# HISTORIC PRESERVATION REVIEW BOARD STAFF REPORT AND RECOMMENDATION

Landmark/District: Address:	Mount Pleasant Historic District 3118-3120 16 <sup>th</sup> Street NW	(x) Agenda
Meeting Date: Case Number:	May 26, 2016 16-312	<ul><li>(x) Addition</li><li>(x) Alteration</li><li>(x) Subdivision</li></ul>
Staff Reviewer:	Tim Dennée	( <b>x</b> ) Concept

The applicant, Rich Markus, architect and agent for the property owner, Pleasant 16<sup>th</sup> LLC, requests the Board's further review of a concept to combine two buildings—which will require a subdivision—and to construct rear, roof and side additions. The combined houses would become a condominium apartment building.

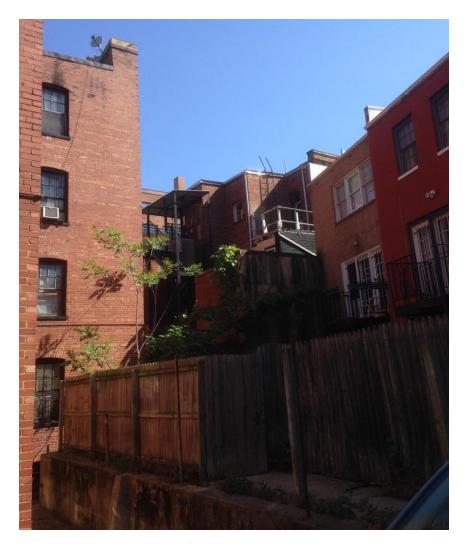
The addition atop the little south-side wing of 3118 has been revised in a couple of significant ways. There is more glazing, but it has not quite taken on the character of a side porch. The roof, now a slate-clad hip, is not characteristic of a side porch. When the Board requested that the tile roof not be continued onto the side addition, it was not merely a matter of differentiating new construction from old. Continuing the roof, but in slate, is a jarring incompatibility. The staff understood the Board's direction to mean that the addition roof should be detached from the main roof, i.e., that it be lower and flatter.

Of course, the effect of lowering the roof in this proposal would be to further expose to view the roof addition and air-conditioning equipment. The present roof is meant principally as a screen.
